## **CM and Cryo meeting #3**

6/19/2017

# Director's Review

## 2.0 Introduction

## Progress on the Lifting

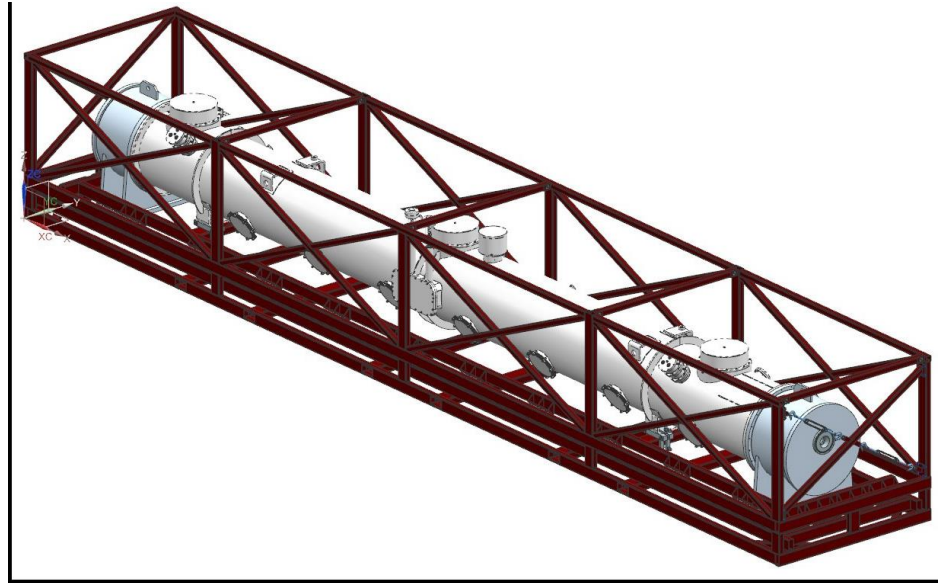
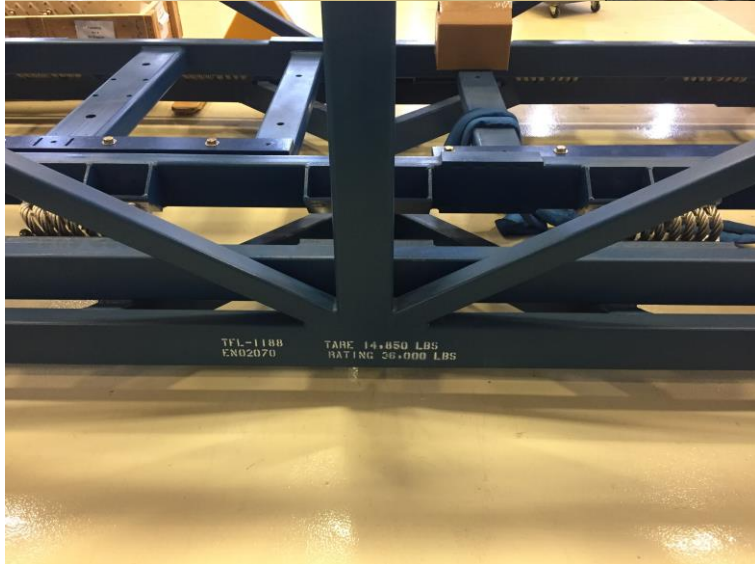
- Preliminary results from Heng pen shows that supporting the Cold Mass in the middle is necessary
- Also it is clear that 1g is not on issue at any direction for the cold mass
